Comprehensive Traffic Study at Delmar & I-170

Traffic Study
University City, Missouri

Prepared for:

City of University City

Figure 7. Delmar Mixed Use Site Plan (Provided by Others)

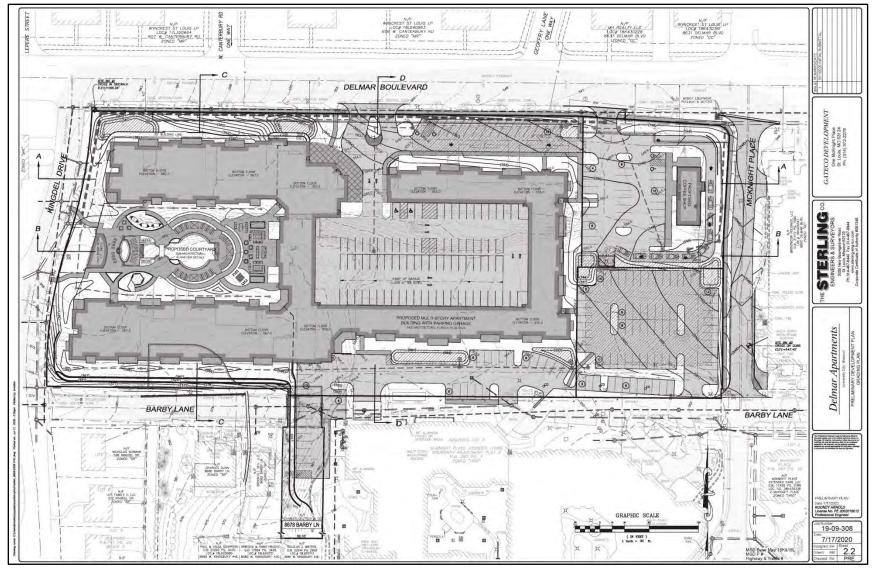
The proposed site plan does not provide cross access to the existing Gatesworth Community. Cross access is vital as tenants of the Gatesworth community should be able to access the proposed coffee shop without having to rely upon Delmar Boulevard and thereby add unnecessary turning movements. LochGroup recommends providing cross access between the site and the Gatesworth community in order to improve access and circulation.

The two-way traffic flow proposed for the parking garage appears acceptable. The proposed traffic flow pattern throughout the site appears acceptable as well. It should be noted that the drive-thru for the proposed coffee shop only has room for ten vehicles. Drive thru queues for a coffee shop typically range between 7 to 13 vehicles. While the proposed supply is within that range, it may be prudent to provide additional analysis specific to the proposed coffee shop to ensure that there is enough room for vehicles to queue in the drive-thru lane without spilling into the parking lot. It is important to note, that if the drive-thru queue exceeds 10 vehicles, the vehicles will queue within the parking lot and should not impact Delmar Boulevard.
